TVA-BFN-TS-434

**BROWNS FERRY NUCLEAR PLANT (BFN) UNIT 1 - TECHNICAL  
SPECIFICATION 434 - LOWERING THE ALLOWABLE VALUE FOR REACTOR  
VESSEL WATER LEVEL - LOW LEVEL 3**

**TECHNICAL SPECIFICATION CHANGE (TS-434) -  
LOWERING THE ALLOWABLE VALUE FOR REACTOR VESSEL WATER  
LEVEL - LOW LEVEL 3**

PROPOSED TECHNICAL SPECIFICATION CHANGES (MARK-UP)

Figure: Instrument Value Relationships

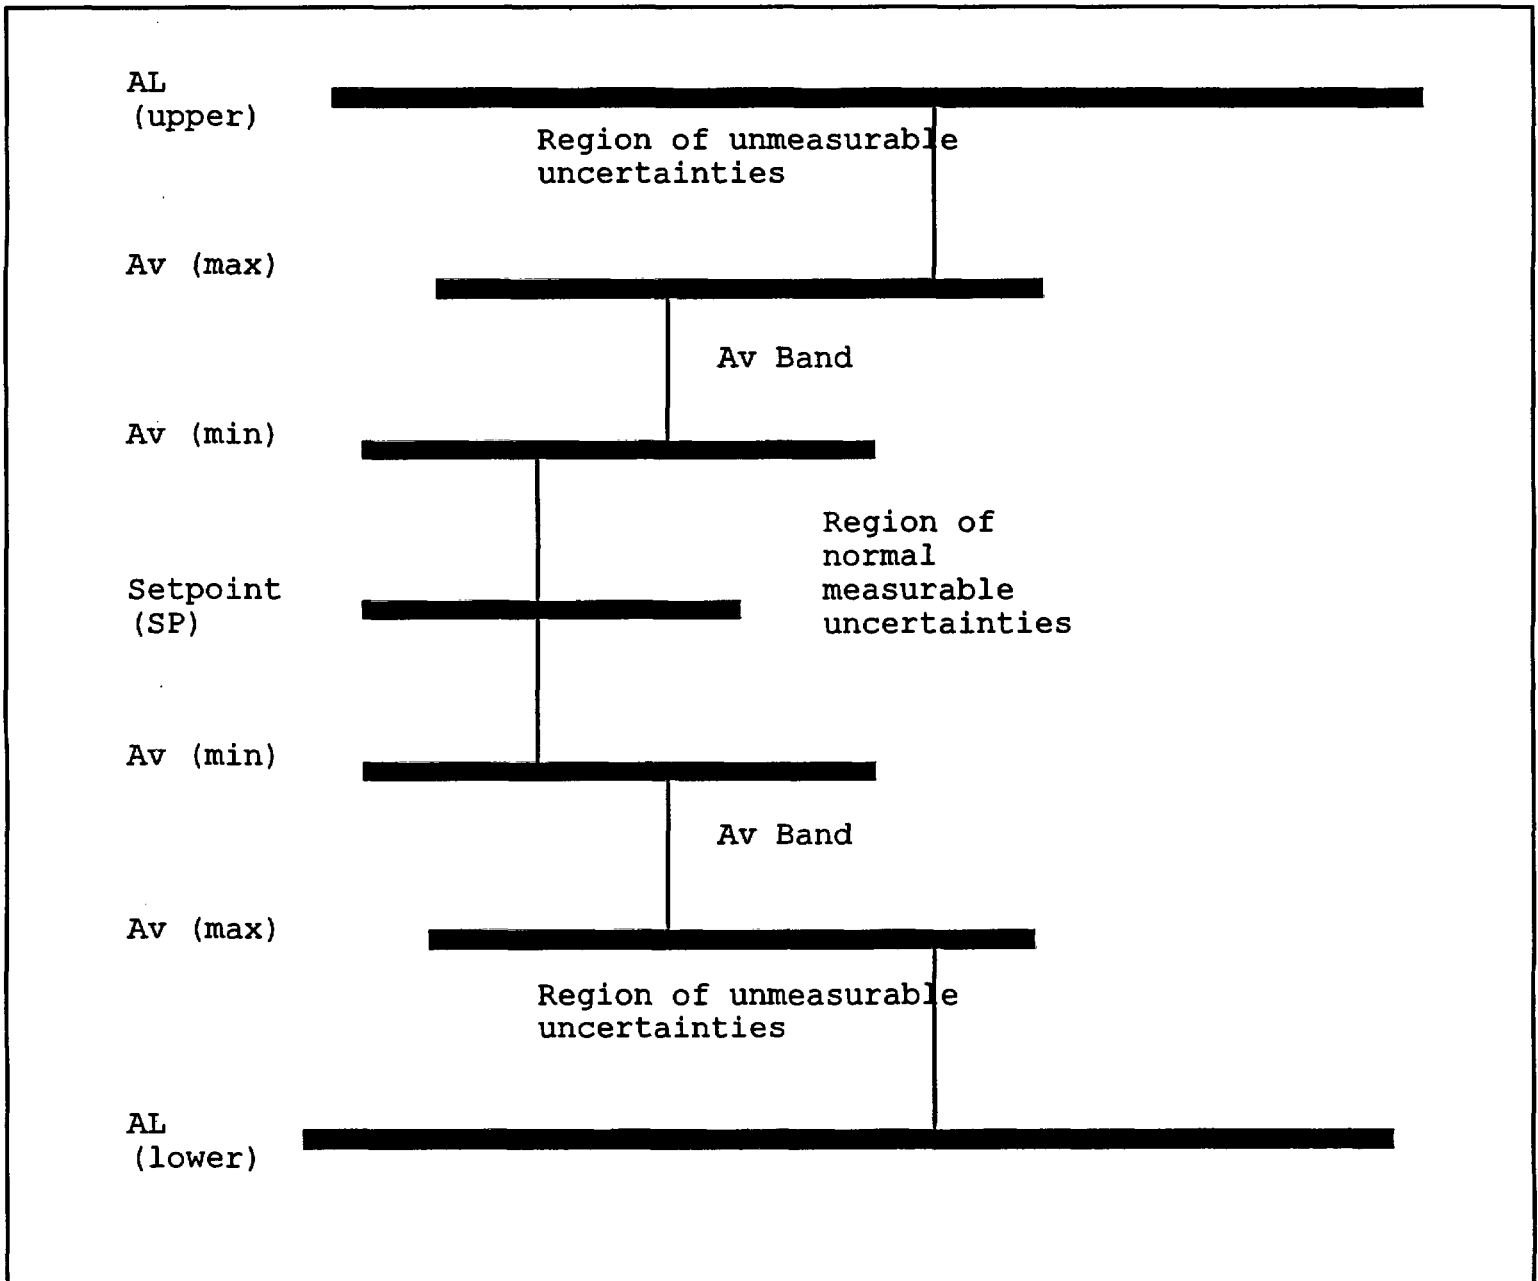
The attached figure illustrates the relationship between the setpoint, the minimum and maximum acceptable Allowable Values [Allowable Value (min) and Allowable Value (max)], and the Analytical Limit for a process that decreases toward the setpoint. To provide operational reliability and to ensure that the instrument will perform its design basis function, the Technical Specification Allowable Value is established within the "Allowable Value Band."

The current Technical Specification Allowable Value is based on an Analytical Limit of 530 inches above vessel zero. In the safety evaluation for this proposed change, a conservatively low Analytical Limit value of 512 inches above vessel zero was used. This 512 inches value is actually below the lower instrument tap located at 517 inches. Since the water level instruments cannot physically measure levels below the instrument tap, the proposed Technical Specification Allowable Values and setpoint calculations are based on an assumed Analytical Limit of 518 inches. This is a conservative approach and provides additional margin in the safety evaluation.
